SIB 51 02 20 RATTLE NOISE FROM COWL TRIM

E-Series	Model Description	
G20	3 Series Sedan

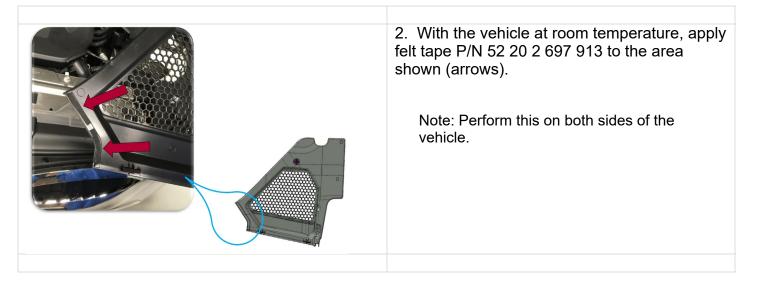
At temperatures below 50°F, the cowl panels below the windshield can contact the adjacent panels.

Insulate the cowl panels on both sides.
